City of Kodiak
Baranof Park Improvements; Ice Rink PN 19-03/9018
Addendum No. 4
April 21, 2022

The following change(s) and/or clarification(s) are made to the Plan and Specification Documents of Invitation to Bid for the Baranof Park Improvements; Ice Rink PN 19-03/9018:

3 LIGHTING CONTACTOR 'LC-1'

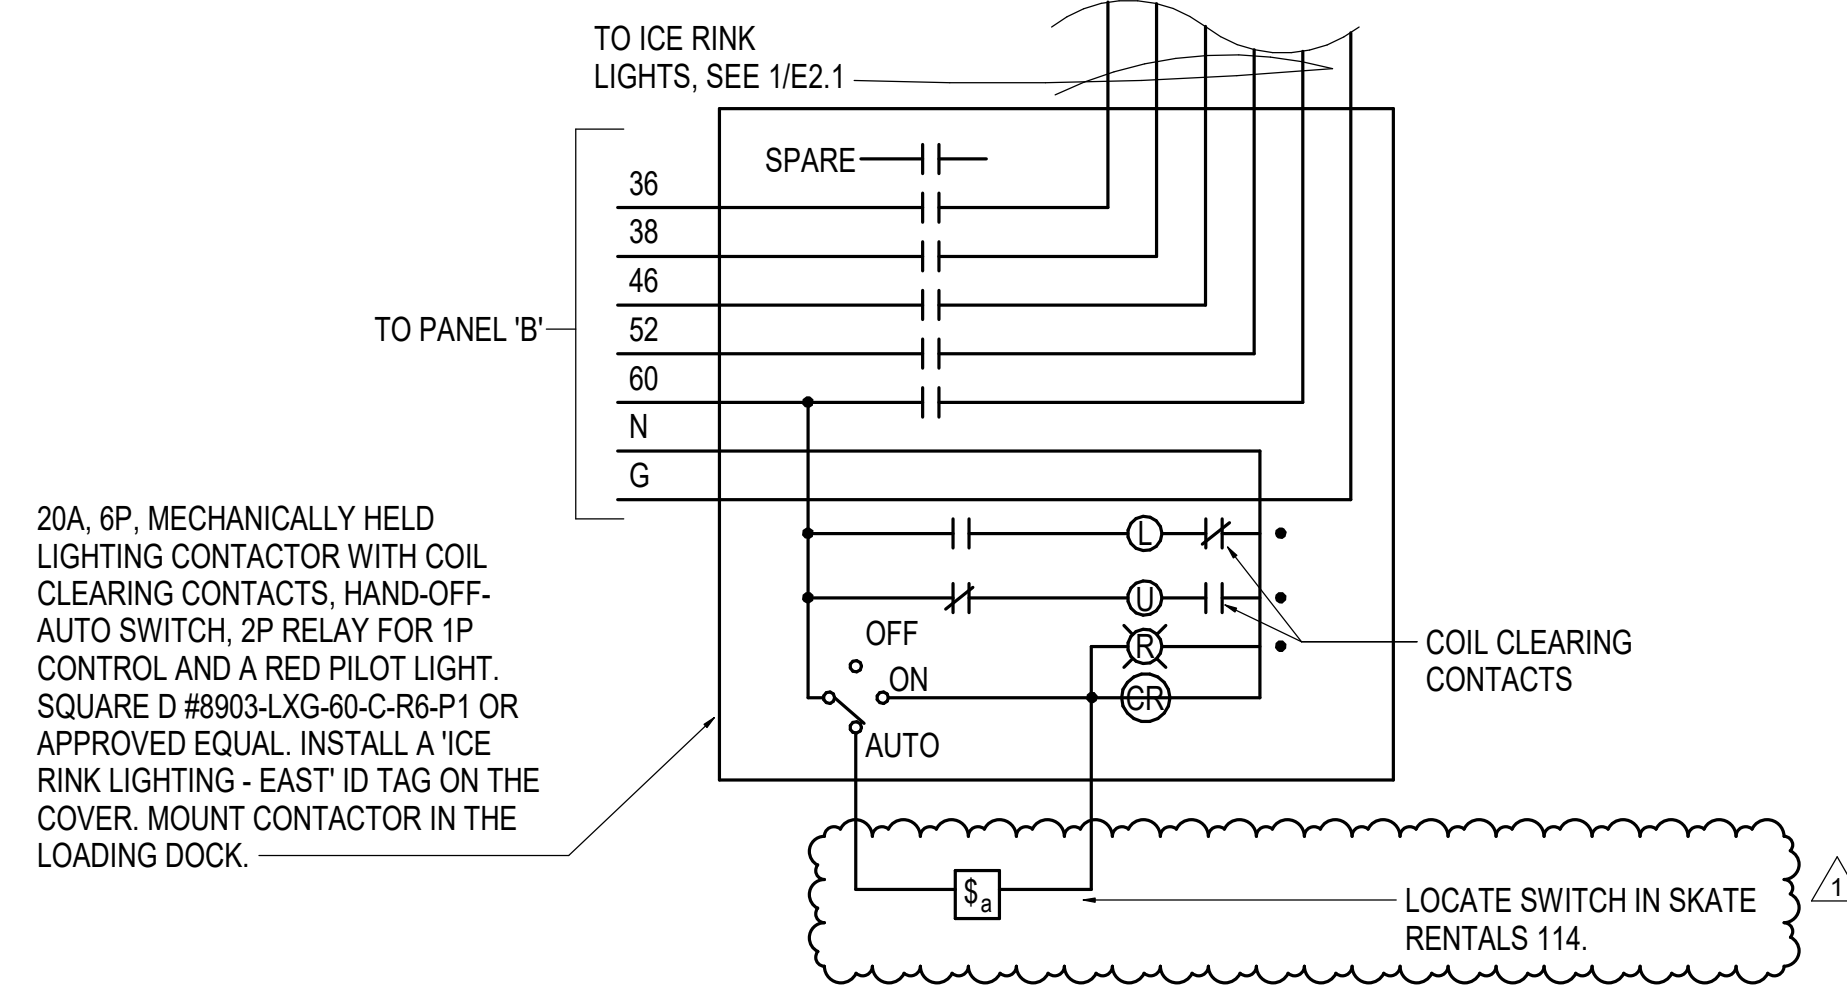
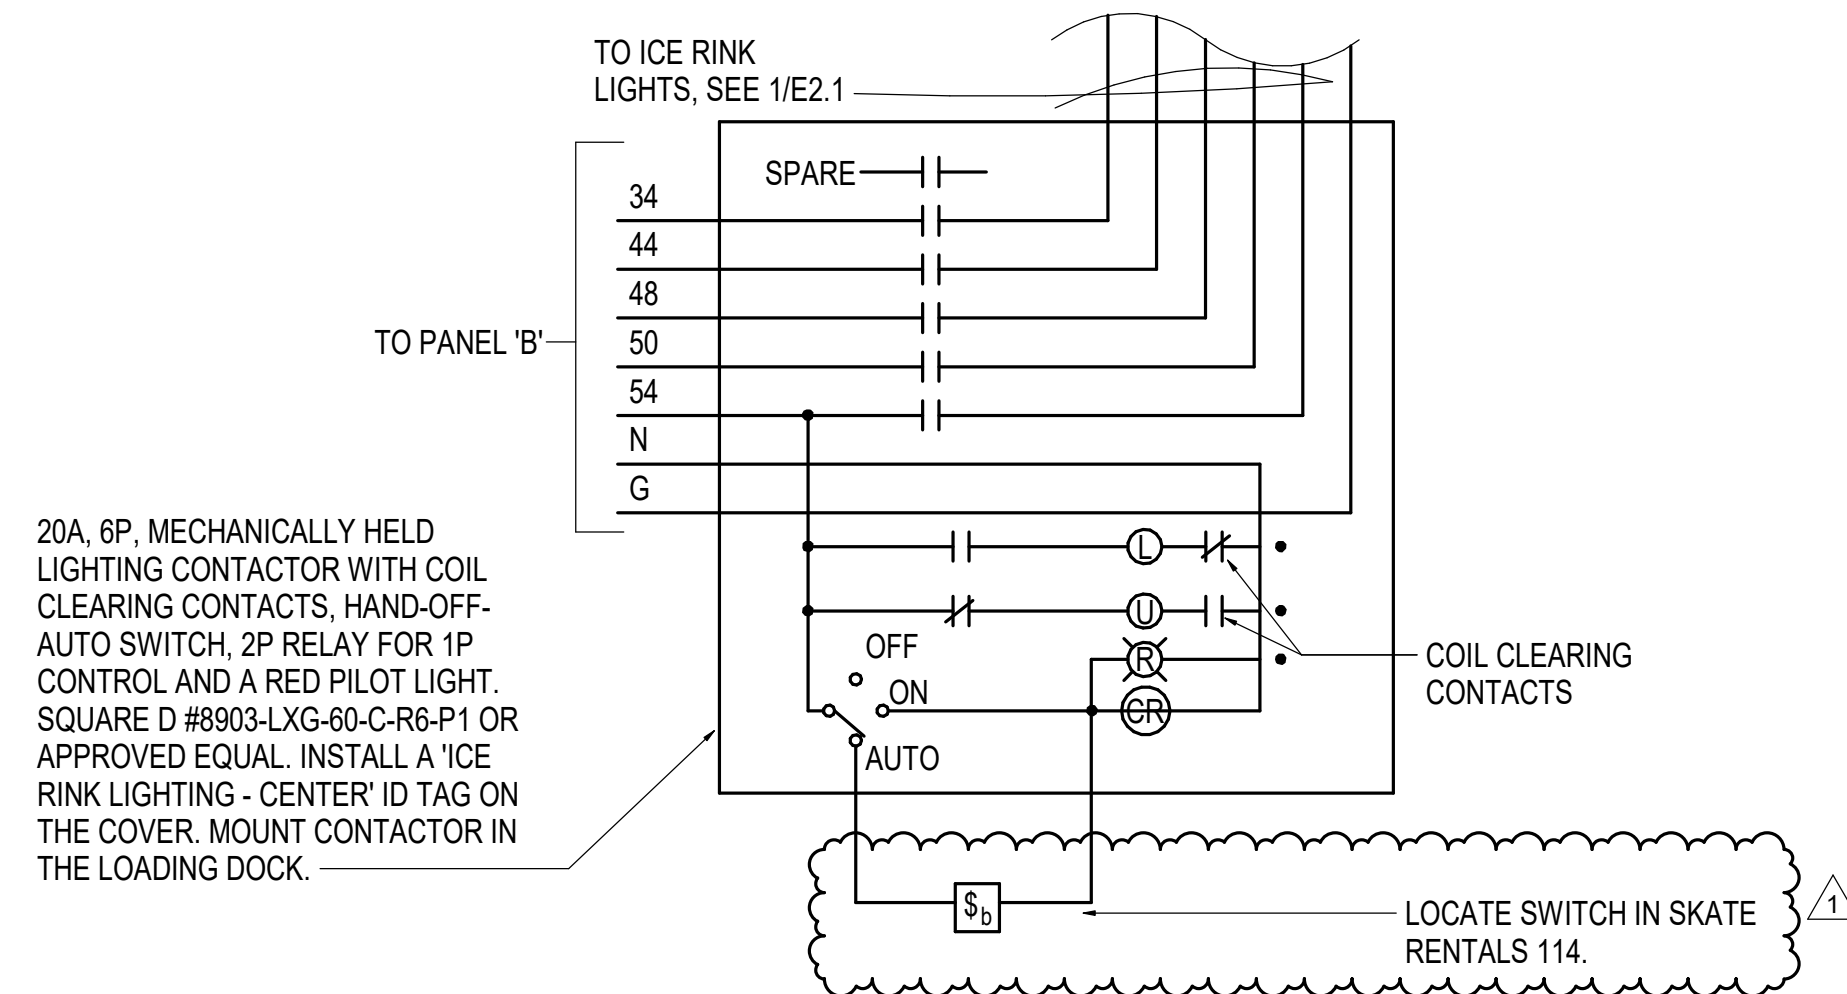
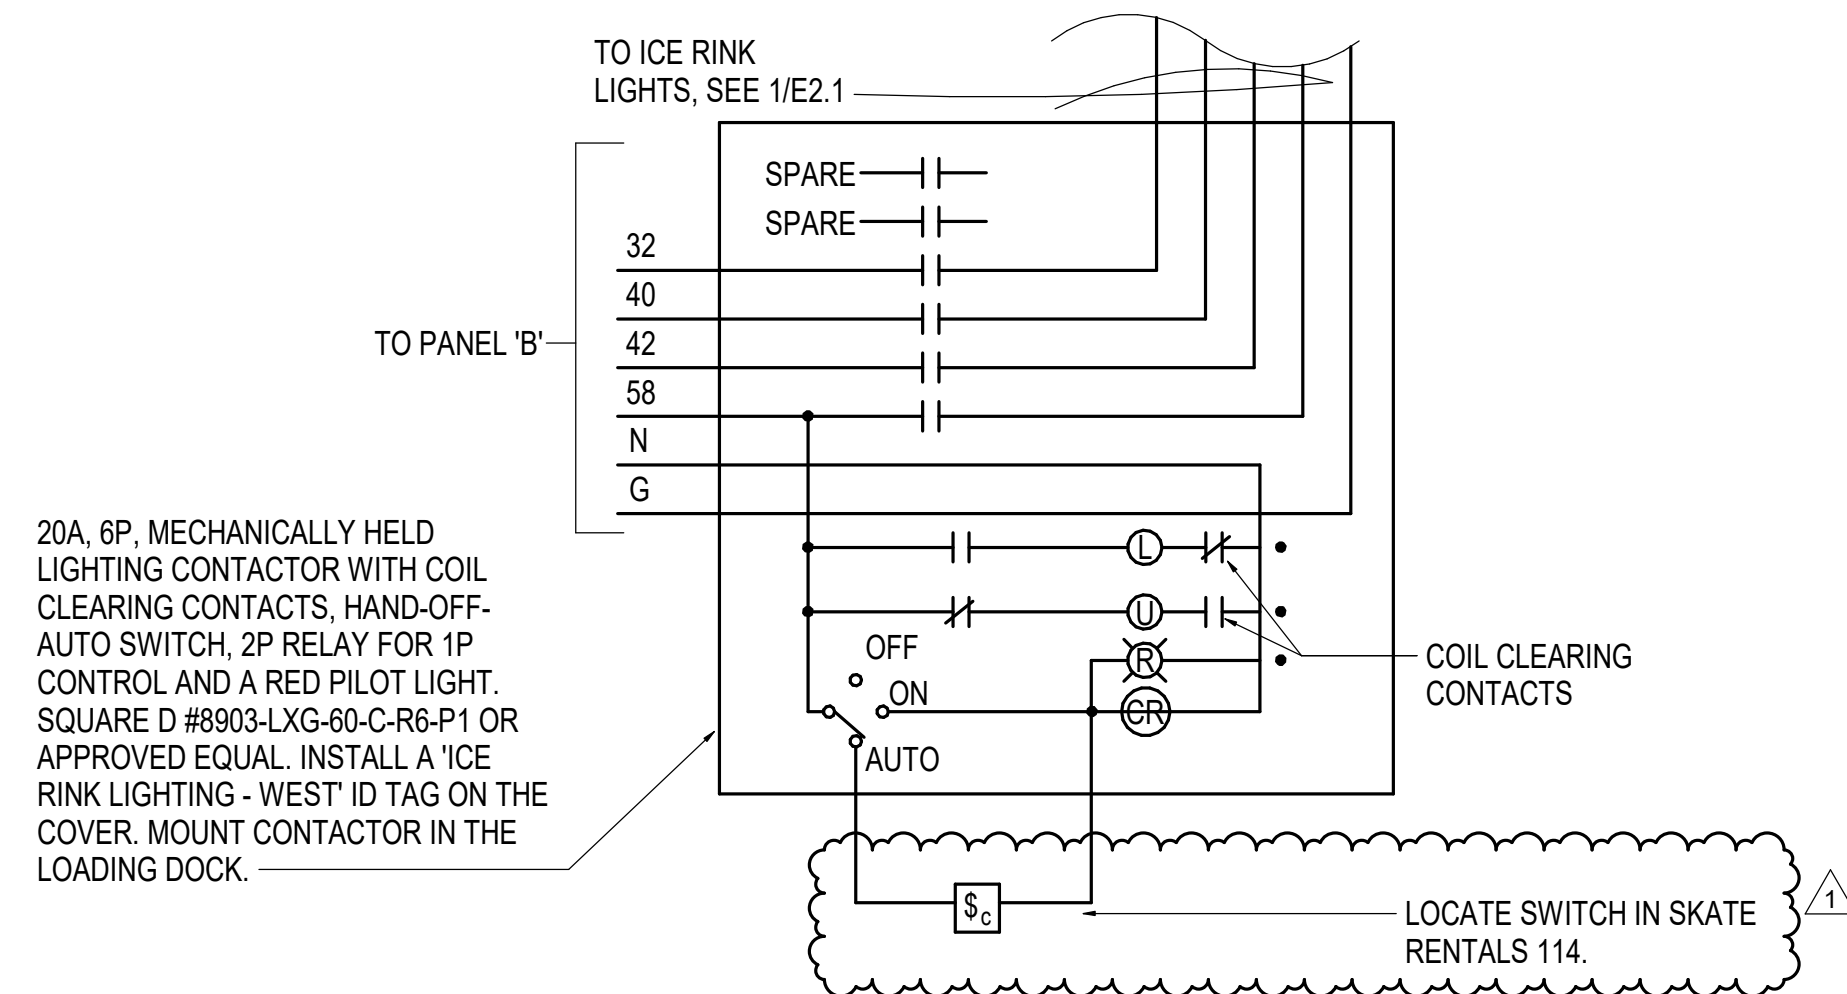
- a) Question: Are they sure they want to put 3 way and 4 ways switches to control the ice rink lights. It might be better to leave a couple lights on and put switches in office?

Answer: Please see attached drawing revisions to the lighting sheets (sheets E2.1 and E6.1) to accommodate the deletion of the 3-way and 4-way switches, relocation of one bank of switches into the Skate Rental Room 118, the deletion of occupancy sensors in the entry area, and the night lights in the rink area.
